NOTICE OF DECISION
CITY OF WOODBURN, OREGON
DIRECTOR OF ECONOMIC AND DEVELOPMENT SERVICES

FILE NUMBER: DR 2010-04
DATE OF DECISION: June 18, 2010
APPLICANT: Hope Lutheran Church
PROPERTY OWNER: Hope Lutheran Church

SUMMARY OF PROPOSAL: The applicant requested a Type II Design Review for a 720 square foot garage and storage building accessory to an existing house of worship.

Findings and Decision

Building elevations

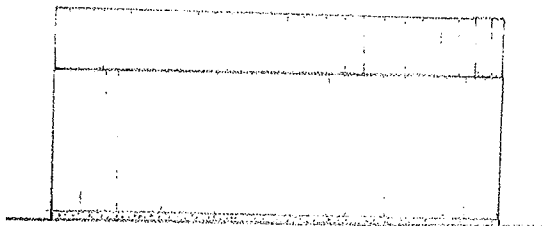
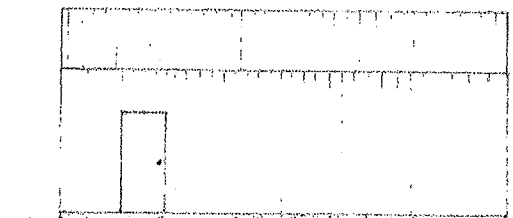
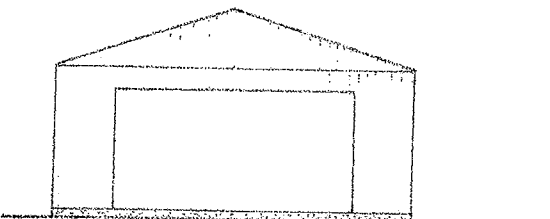
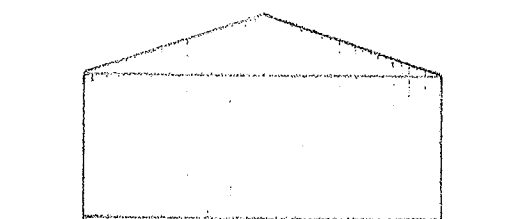
Findings: Section 2.103.06.B provides that the maximum height of buildings shall not exceed 35 feet. Elevation drawings show the proposed garage to be approximately 12 feet in height, per the definition of building height in Section 1.102.

Findings: Section 2.103.06.B provides that the maximum height of buildings shall not exceed 35 feet. Section 2.202.02.A provides that the maximum height for accessory structures be the same as for primary structures. Elevation drawings show the proposed garage to be approximately 12 feet in height, per the definition of building height in Section 1.102.

Findings: Section 3.107.06.B.1.a provides that “Building facades visible from streets and public parking areas *should* be articulated in order to avoid the appearance of box-like structures with unbroken wall surfaces.” The floor plan shows a rectangular structure without articulation.

The project drawings show a rectangular structure without passageways through the building, wall offsets or projections, variation in building materials or textures, or arcades, awnings, canopies or porches.

visual interest of wall surfaces and harmonize with the structural design.” The exterior elevation drawings and submittal photographs show standing seam metal siding for the entire building.

The exterior elevation drawings and submittal photographs show standing seam metal siding for the entire building, no windows, and a cream finish color.

The exterior elevation drawings show the building to have a single gable-end roof.

Conclusions: The proposed garage does not meet the guideline of WDO 3.107.06.B.1.a. Guidelines are not mandatory standards. A project may be approved even is it does not comply with all stated guidelines.

Conclusions: The proposed garage does not meet the guideline of WDO 3.107.06.B.1.b. Guidelines are not mandatory standards. A project may be approved even is it does not comply with all stated guidelines.

Conclusions: The proposed garage does not meet the guideline of WDO 3.107.06.B.2.a. Guidelines are not mandatory standards. A project may be approved even is it does not comply with all stated guidelines.

Conclusions: The proposed garage does not meet guidelines 1-3 of WDO 3.107.06.B.2.b, but does meet guideline 4. Guidelines are not mandatory standards. A project may be approved even is it does not comply with all stated guidelines.

Conclusions: The proposed garage does not meet the guideline of WDO 3.107.06.B.3. Guidelines are not mandatory standards. A project may be approved even is it does not comply with all stated guidelines.
